Safety Defect and Noncompliance Report Guide for Vehicles PART 573 Defect and Noncompliance Responsibility and Reports

Ricon Recall Notification (#07E-095)

Recall # 07E-095 Threshold Warning System

Subject:Part 573 Defect and Noncompliance Responsibility Report – Threshold Warning SystemReference:FMVSS 403 compliant S & K-series Public and Private Use Lifts

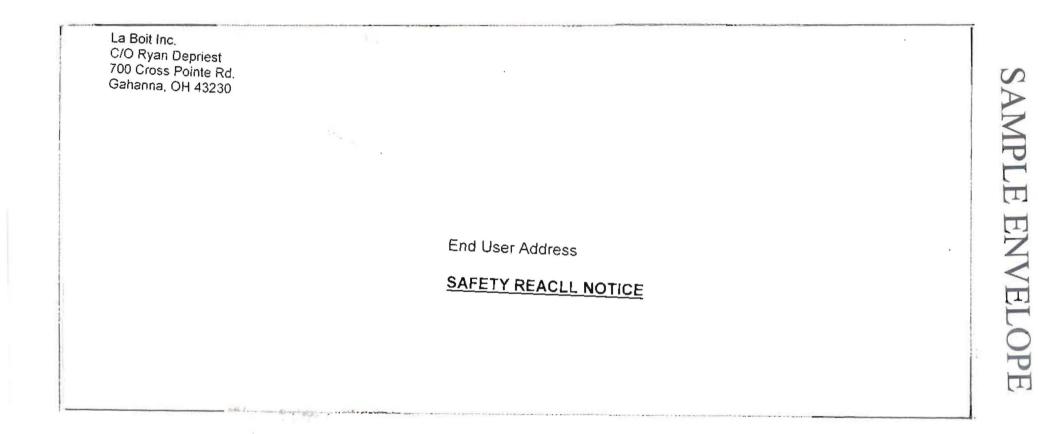
The non-compliance with S6.1 of the FMVSS 403 is the result of the Threshold Warning System not detecting the presence of a wheelchair or mobility aid user in a certain spot within the defined threshold area. In the event this condition occurs during passenger operations the wheelchair or mobility aid user may move toward the vehicle lift door when the lift platform is below floor level. This situation could cause personal injury. **WHAT YOU SHOULD DO:**

You will require Kit # 39979, supplied by Ricon at no charge

- 1. Park the vehicle in a safe location.
- 2. Locate and remove 2 bolts at the bottom of the Threshold Warning System (TWS) covers on the inboard surfaces of the right and left side baseplate towers.
- 3. Slide the covers up to remove top cover clips from towers.
- 4. Remove optical sensors and retainer clips from inside the two cover assemblies.
- 5. Reinstall sensors into new TWS covers with new retainer clips provided.
- 6. Slide new covers over towers and reinstall the 2 bolts at the bottom of the towers.
- 7. Discard original parts.
